**ANGEL PLACE
LEVEL 8, 123 PITT STREET
SYDNEY NSW 2000**

13 January 2021

RE: CURRAWONG BEACH IDA N0281/17, SECTION 4.55 AMENDMENT TO THE DESIGN OF CABIN NO.1 KOOKABURRA - HERITAGE IMPACT STATEMENT

Figure 2 The existing approved scheme for Cabin 1 (Kookaburra) with the original extent of the cabin shaded in red. The existing deck and timber walkway to the WC are shaded yellow. The walkway was to be demolished. However it has been decided to retain the Angophora tree shown shaded brown.

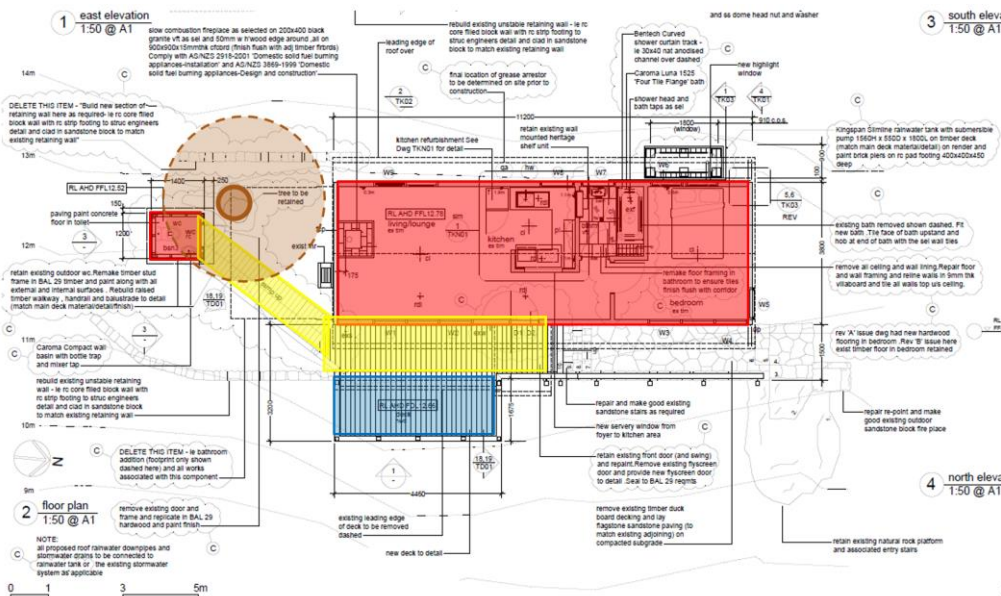
- Delete the approved building addition.
- Allow the careful restoration of the outdoor WC and timber framed walkway leading form the main deck.
- Allow slimline water tank and hardwood timber stand to the western elevation.
- Delete the approved demolition of interior partition walls at the existing bathroom.
- Allow new fit out of existing bathroom.

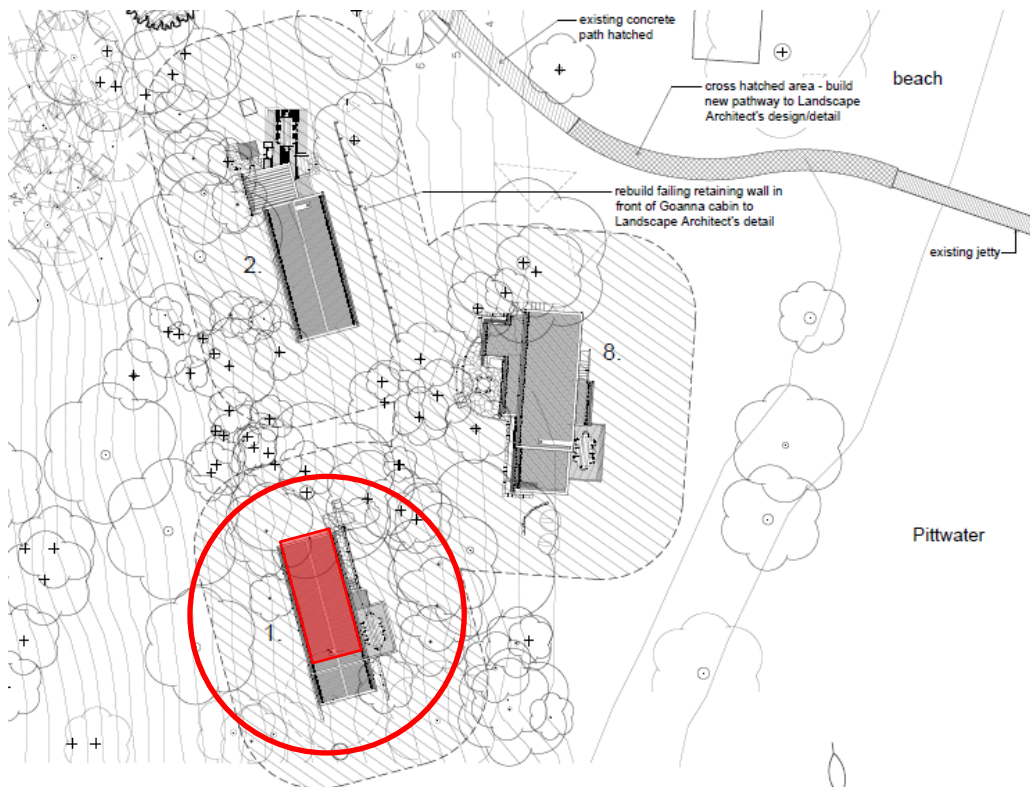
Figure 3 The proposed s4.55 amendment with the original extent of the cabin shaded in red. The Angophora tree is retained. The existing timber walkway to the WC is rebuilt in timber with a handrail to match the deck. The existing deck is still widened to provide an outdoor dining area as shown shaded in blue.
